IREDELL COUNTY HEALTH DEPARTMENT

IMPROVEMENT PERMIT / AUTHORIZATION TO CONSTRUCT / OPERATION PERMIT / EXISTING SYSTEM INSPECTION

PERMIT# 086151 PIN# 4639-53-~~4457~~-542A DATE 1-25-05

SUBDIVISION HAWKS BAY BLOCK / SECTION LOT 35 LOT AREA 37066 ft² SITE CLASS. PS DESIGN FLOW 480 L.T.A.R. .3

INITIAL SITE SKETCH

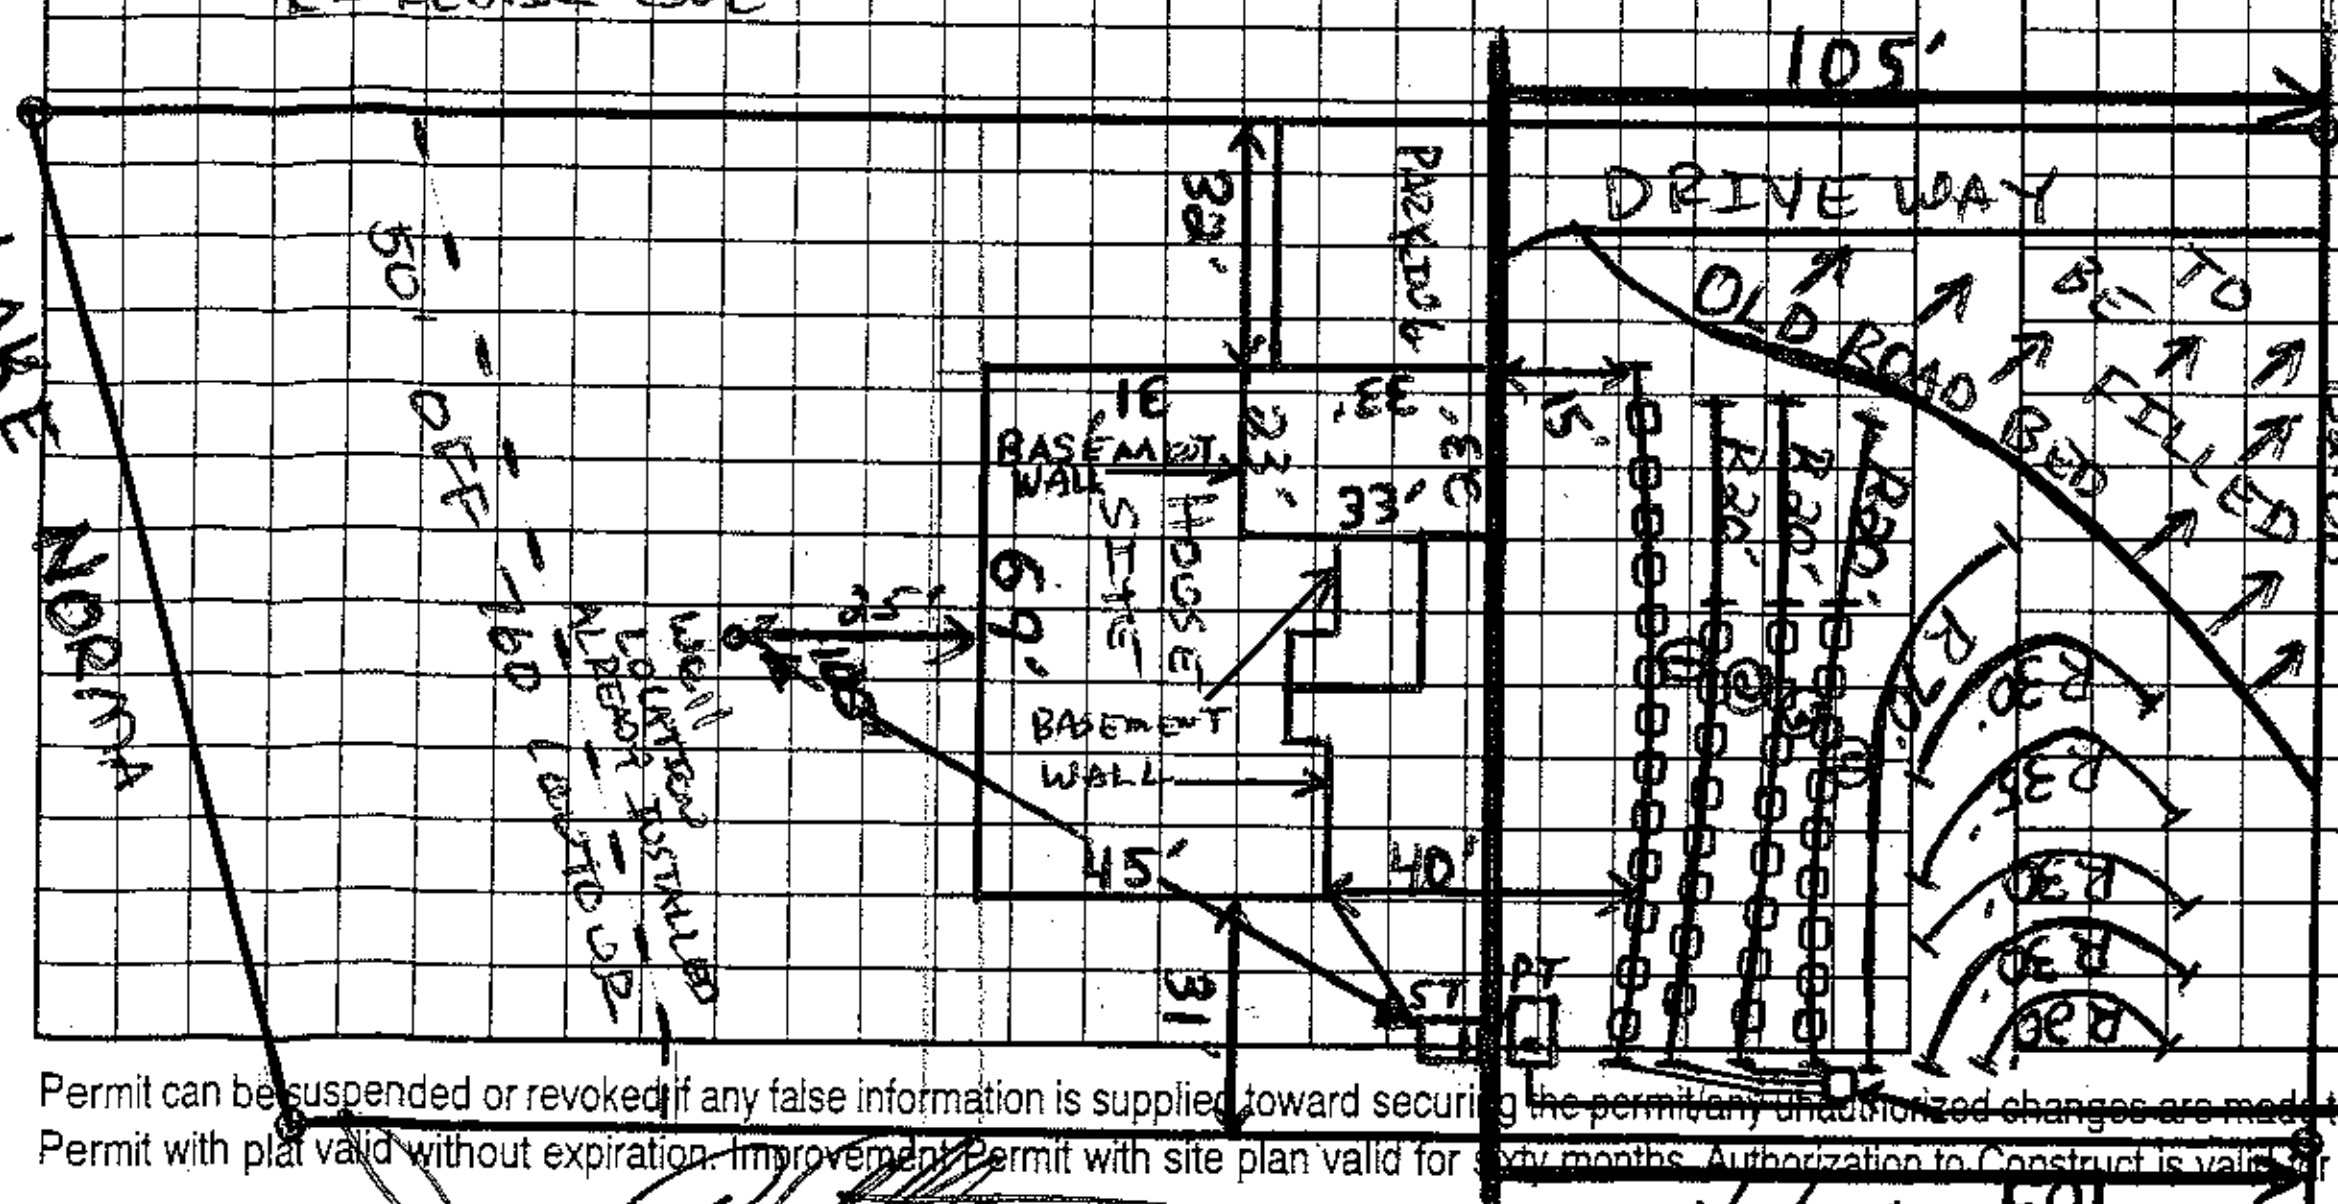
Comments:/Conditions: (1) INSTALL LINES ON CONTOURS & MAINTAIN SETBACKS (2) FILL & PACK OLD ROAD BED CUT, RUN LINES 5' OFF OF CUT (3) THIS LOT HAS 268' OF LINE LENGTH FOR THE INITIAL & REPAIR. (4) DO NOT ALTER PERMIT OR SITE OR PERMIT WILL BE VOID (5) CALL PRIOR TO INSTALLATION FOR PUMP SIZING & SYSTEM SPECS IF NECESSARY. (6) INITIAL & REPAIR AREA IS COMPLETELY FLAGGED OUT EVERY 10' (7) BASEMENT PLUMBING WILL REQUIRE AN IN HOUSE PUMP TO PUMP TO FLOOR LEVEL PLUMBING & THEN EXIT OUT (8) KEEP WELL 100' FROM ANY PART OF SYSTEM (9) FENCE OFF SYSTEM & REPAIR FROM VEHICULAR TRAFFIC DURING BUILDING. (10) KEEP HOUSE OUT OF GROUND & BACKFILL FOR POSITIVE DRAINAGE REQUIREMENTS. IF NOT PERMIT WILL BE VOID (11) KEEP STUBOUT HIGH ENOUGH SO PROPER FALL CAN BE ACHIEVED TO THE SEPTIC TANKS. IF SEPTIC TANK IS TO DEEP, REINFORCED TANKS WILL HAVE TO BE USED. (12) THIS IS A LIMITED REDRAW, INITIAL SOIL WORK WAS DONE BY DAVID HINSON, R.S.

POLYLOC FILTER & MARKER
NEED PERMISSION TO MOVE TANKS.
✓ SYSTEM PRESSURE, NEEDS ELECTRICAL & CONTRACT & PERMISSION, [illegible] 5-17-05
BUILDER OK'S TANK CHANGE. [illegible]
✓ NOT UPSLOPE FROM DRAIN
NEEDS CONTRACT & SIM TECH FILTER RECEIVED & ✓ 7-22-05
